RESOURCE CONSENT APPLICATION:

**LUC-2018-679
43 CARGILL STREET
DUNEDIN**

The Committee has **granted** consent to the application on 11 November 2020. The full text of this decision commences below with a consent certificate attached to this letter.

L.U.C. REVISE 2 Layout removing 1 Habitable Room

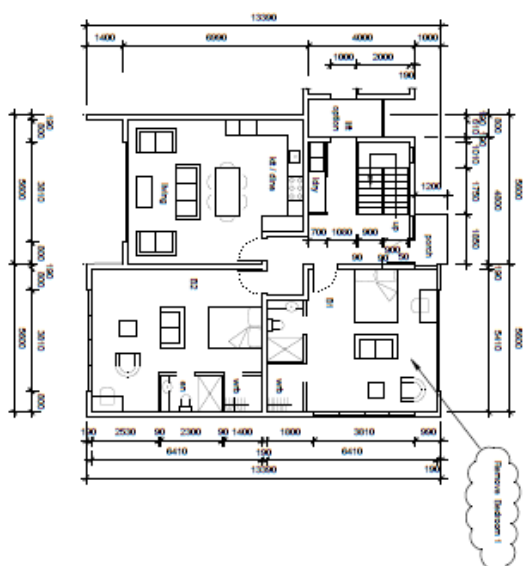
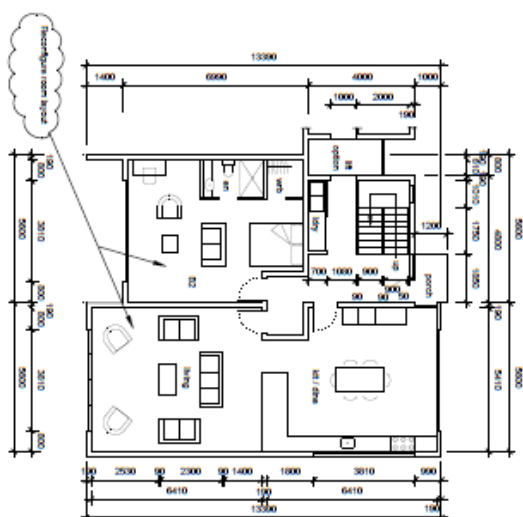
Remove Bedroom 1 and reconfigured layout of rooms on Ground Floor Unit 4, in line with 2GP mediated site density resolution being 1 habitable room / 30m² of site area, Equivalent of 31 Total Habitable rooms / 934m² site.
